ADDENDUM #3 BID NO. 20-58-3300

For: ***Purchase and installation of Kantech access control systems for Fowler WRF***

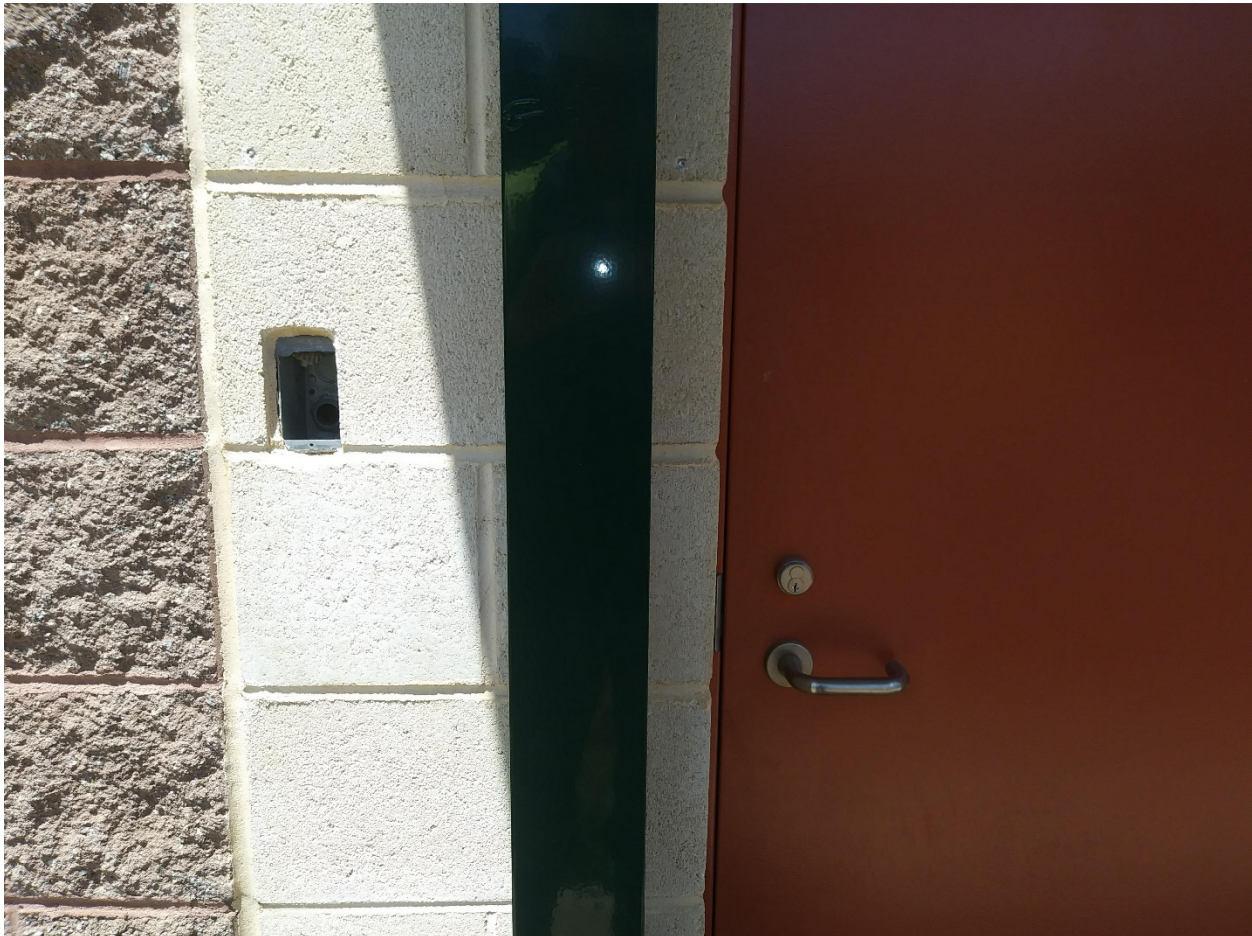
1. Is there a network connection available at all controller locations?
Answer: Network Connection is available at each location within approx. 20 ft of each controller.
2. Is the connection to the gate desired to be copper or fiber optic?
Answer: Connection to the gate is to be CAT 6 fiber.
3. Are the doorframes free of concrete to allow door strike installation?
Answer: Yes.
4. Page 12 of the spec states all conduit to be provided by the county. Does this include junction boxes and connection locations to the card reader and strike locations?
Answer: Yes, conduit and boxes are to be provided by the county (but wire is not provided) to the card reader. Any needed conduit or pathways to the strike location from the reader are to be provided by the bidder. See photo attached below.
